Serial No. 96-409A  
NO&LS/ETS  
Docket Nos. 50-338  
50-339  
License Nos. NPF-4  
NPF-7

**VIRGINIA ELECTRIC AND POWER COMPANY**  
**NORTH ANNA POWER STATION UNITS 1 AND 2**  
**SUPPLEMENTAL INFORMATION CONCERNING CORE DESIGN MARGINS**  
**AND FUEL MANAGEMENT FOR USE OF FCF LEAD TEST ASSEMBLIES**

### Fuel Management and Inherent Core Design Margins Applicable to Use of FCF Lead Test Assemblies in North Anna 1 Cycle 13

Figure 1

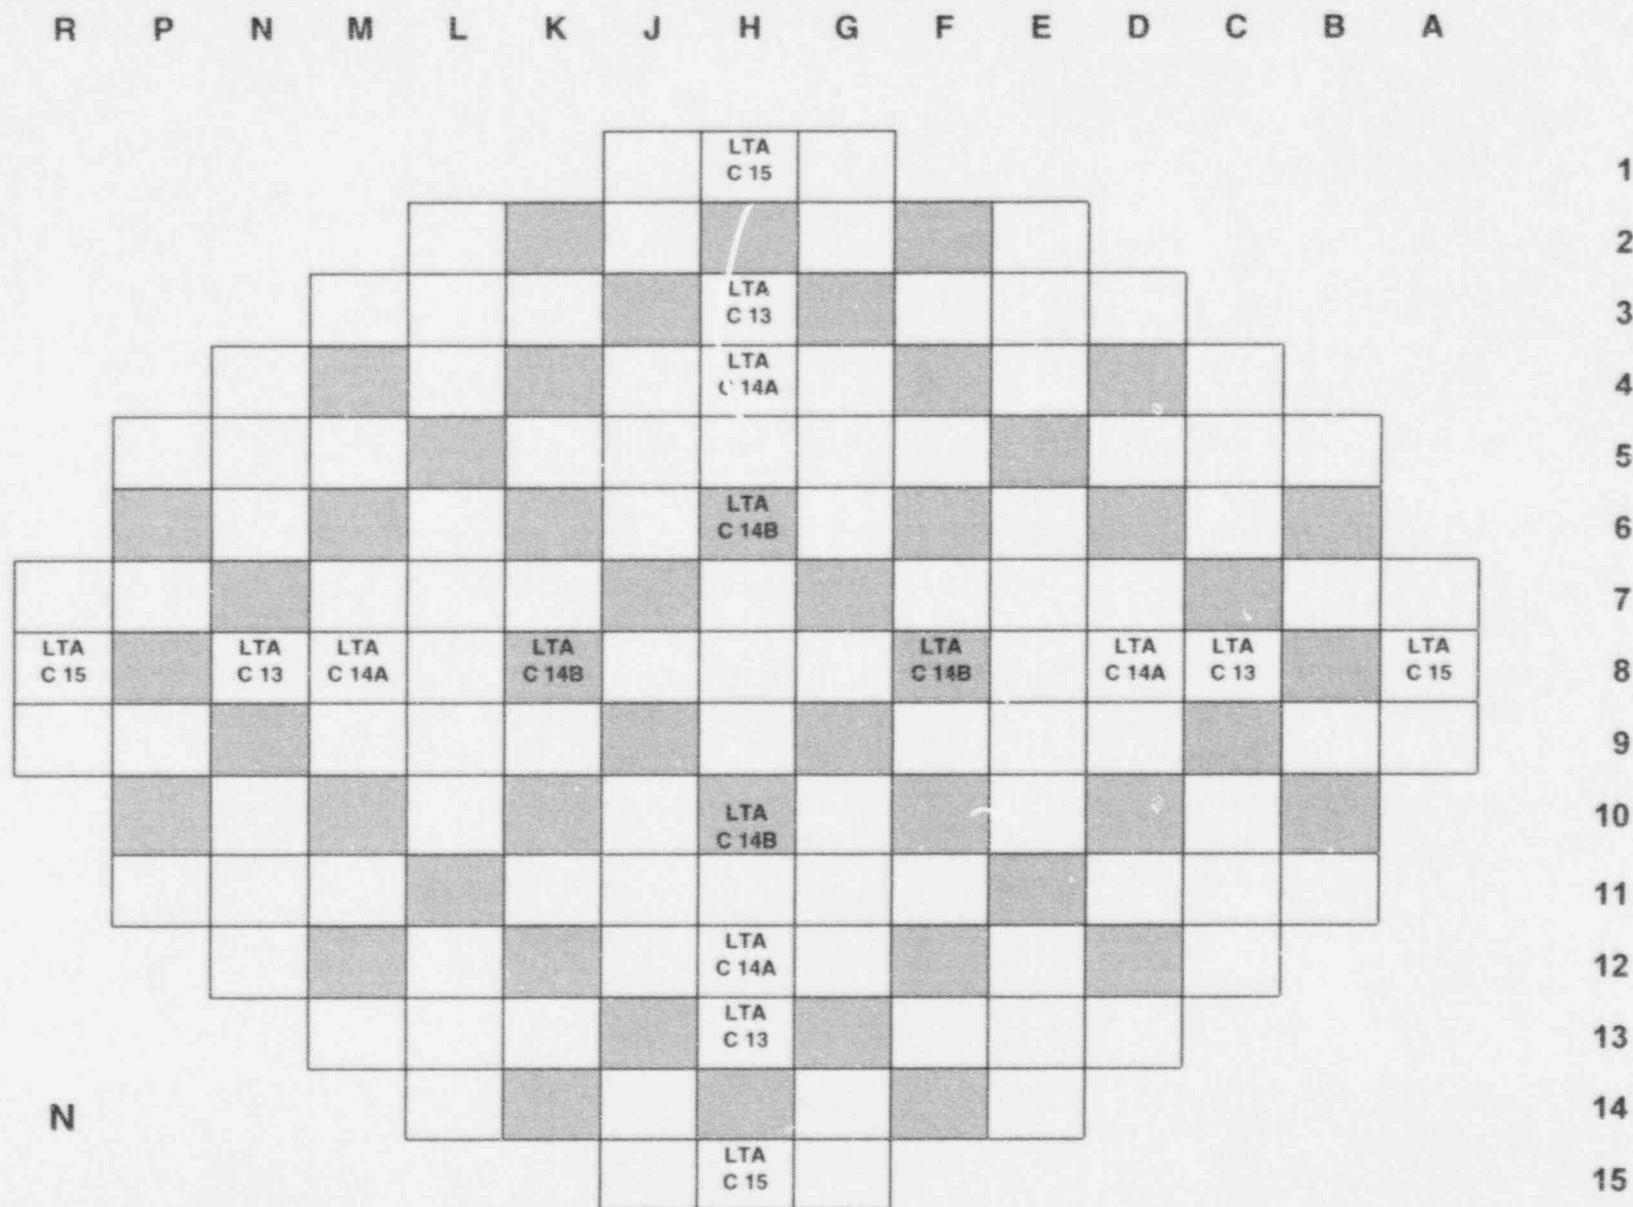
In the first cycle of irradiation (Cycle 13), the proposed core loading pattern incorporates the lead test assemblies in the positions indicated in Figure 1 with 'LTA C13.' In these locations, the lead test assemblies will experience moderately severe duty typical of normal reload fuel. To ensure that the existing safety analyses based on the resident Westinghouse fuel remain applicable, calculation results for the proposed Cycle 13 loading pattern (see Tables 1a, 1b, 2) have confirmed that the FCF assemblies are not in the highest fuel rod power density locations in the core. In addition, the lead test assemblies do not have the highest cycle-averaged assembly average power. The lead test assemblies are not limiting in any key core operation parameters related to rod power density.

Figure 1 indicates by 'LTA C14A' and 'LTA C14B' some of the locations under consideration for placement of the lead test assemblies during the second cycle of irradiation. These locations are typical positions for such once-burned assemblies in North Anna core designs. It should be noted that locations denoted with 'LTA C14B' are under RCCAs. Placement under RCCAs (which is typical for once-burned assemblies) is being considered for the lead test assemblies. A final decision concerning the second cycle position for the lead test assemblies will be made during North Anna 1, Cycle 13 operation. This decision will consider both the advantage of additional incore RCCA experience with this advanced fuel assembly design (beyond the data obtained from control rod drag testing discussed later) and the potential risks of such use in

rodded core locations. In their third cycle, the lead test assemblies are most likely to be placed on the peripheral core locations denoted with 'LTA C15' on Figure 1.
